TSHF5210, TSHF6210, TSHF5410, TSHF6410 - Change in Chip

Product Change Notification

Product Group: OPT/Thu May 11, 2023/PCN-OPT-1275-2023-REV-0

TSHFxxxx PCN - surface emitting chip technology

After PCN – with surface emitting chip technology

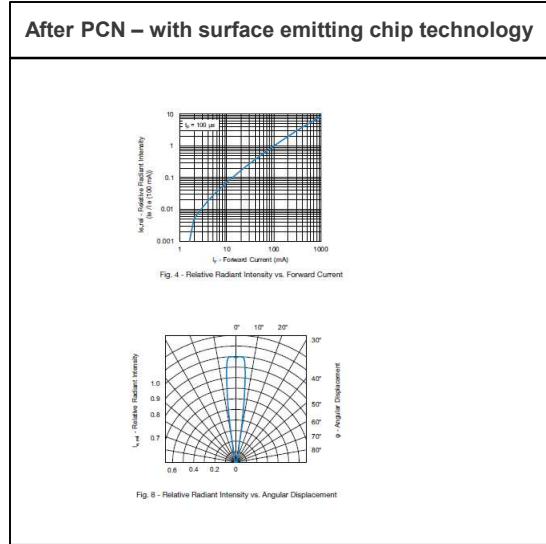
BASIC CHARACTERISTICS (T _{amb} = 25 °C, unless otherwise specified)						
PARAMETER	TEST CONDITION	SYMBOL	MIN.	TYP.	MAX.	UNIT
Forward voltage	I _F = 100 mA, t _p = 20 ms	V _F	-	1.5	1.7	V
Temperature coefficient of V _F	I _F = 1 A, t _p = 100 μs	TK _{VF}	-	3	3.4	V
Reverse current	V _R = 5 V	I _R		-0.8		μA
Junction capacitance	V _R = 0 V, f = 1 MHz, E = 0 mW/cm ²	C _J		55		pF
Radiant intensity	I _F = 100 mA, t _p = 20 ms	I _r	150	327	450	mW/sr
Radiant power	I _F = 1 A, t _p = 100 μs	P _r		3700		mW/sr
Temperature coefficient of φ _h	I _F = 100 mA, t _p = 20 ms	TK _{φh}		-0.3		%/K
Angle of half intensity		φ		±8		°
Peak wavelength	I _F = 100 mA	λ _p		890		nm
Spectral bandwidth	I _F = 100 mA	Δλ		40		nm
Temperature coefficient of λ _p	I _F = 100 mA	TK _{λp}		0.3		nm/K
Rise time	I _F = 100 mA	t _r		10		ns
Fall time	I _F = 100 mA	t _f		10		ns

Fig. 3 - Forward Current vs. Forward Voltage

Fig. 7 - Relative Radiant Intensity vs. Wavelength
